Subject: Proposed Change to the Remedial Action Plan – Specification Revision Related to the Crescent Junction Disposal Cell, Moab Uranium Mill Tailings Remedial Action (UMTRA) Project

The purpose of this letter is to request Nuclear Regulatory Commission (NRC) concurrence on a specification and design drawing change to the Moab UMTRA Project Remedial Action Plan. The U.S. Department of Energy (DOE) is proposing the following changes:

Figure 1. Detail from Drawing E-02-C-501-E showing location of riprap placement on cover edge

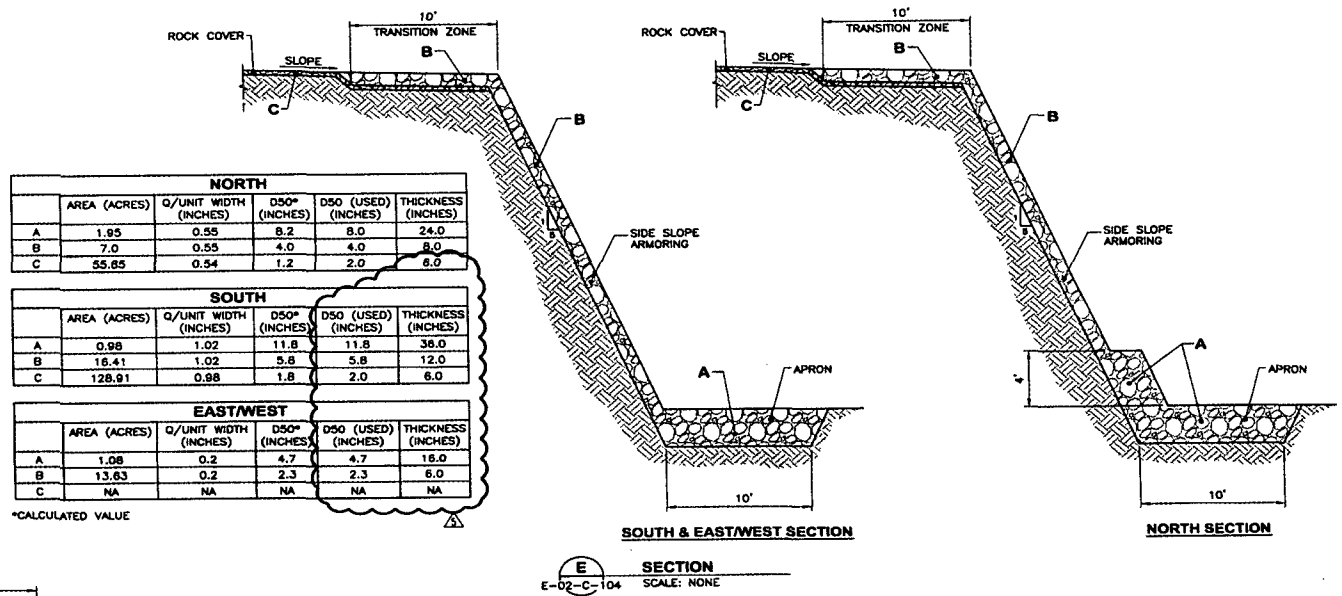
- 1) Drawing E-02-C-501 (proposed changes in the clouded area in Figure 1). The current approved drawing reflects a “calculated” value and a “used value” for the D50 of the rock size. The used values were established by taking the calculated value and in every case but one, rounding up to the nearest standard screen size. The proposed revised drawing below proposes to use the “calculated” as actual for the D50 12-, 6-, and 4-inch rock sizes.

- 2) During a conference call on May 4, 2011, between the NRC and DOE, we discussed the difficulty of sampling and testing riprap gradations. It was suggested that this project should research previous UMTRA projects to see what type of testing and specifications have been used in the past. DOE has reviewed and examined the sampling and testing methods used on previous UMTRA projects located in Green River, UT, and Grand Junction, CO. While reviewing previous UMTRA project specifications, we found that the target gradation bands on past projects are significantly larger than the bands that have been specified on the Moab UMTRA Project. In our letter dated September 15, 2010, we proposed a similar specification change to the aggregate utilized on the final cover (Area C) of the disposal cell, which NRC is currently reviewing. This request is in regard to the side slope riprap (Area B) and apron riprap (Area A) on the same disposal cell (See Figure 1).

4-6" Basalt D50 2.3

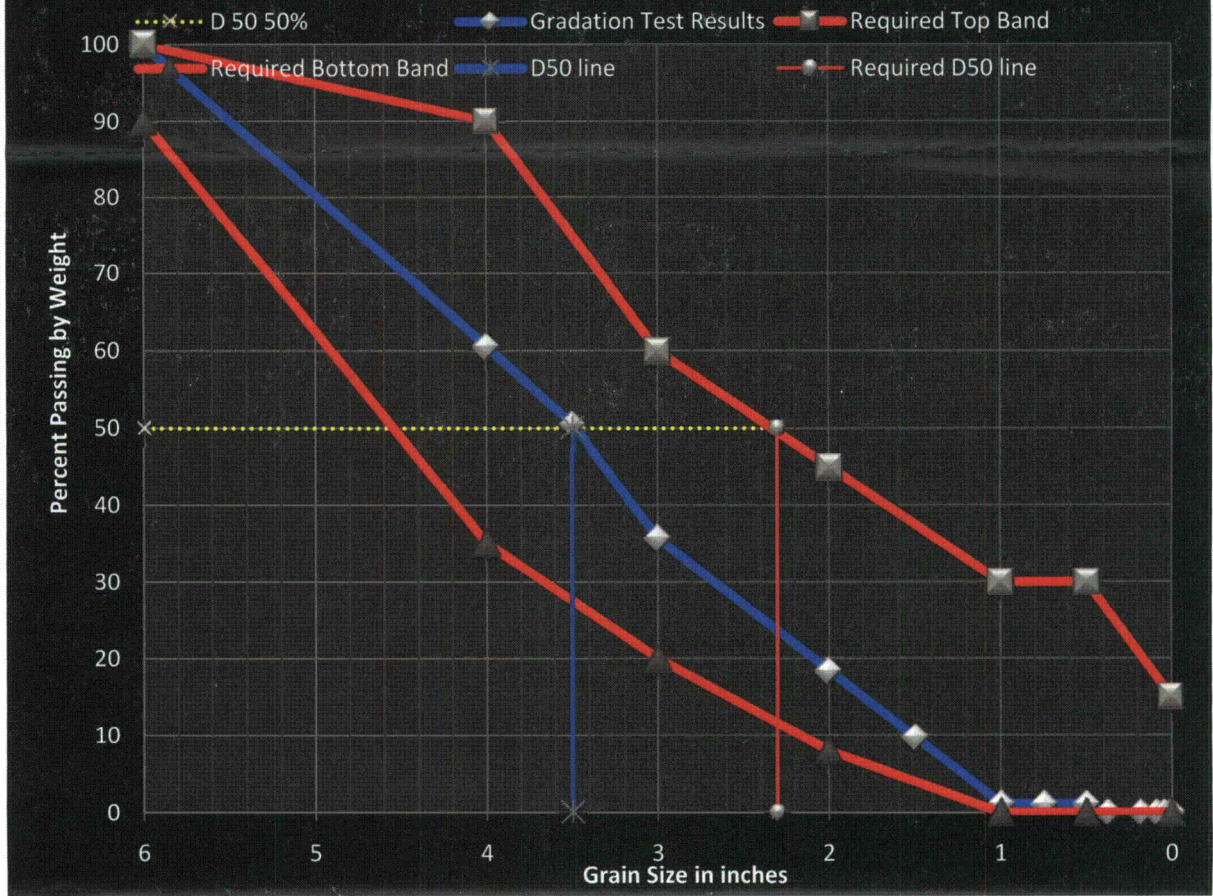
As requested, we have included gradation target graphs (See Attachment A) which show the altered gradation targets in graph form for the riprap material to be used on this project. The intention of these graphs is to show that the targets which have been changed will enable the project to meet the calculated D50 for each specified rock size. The graphs show bands which represent the revised targets and also a line representing the gradation tests that have already been performed on the project to date.
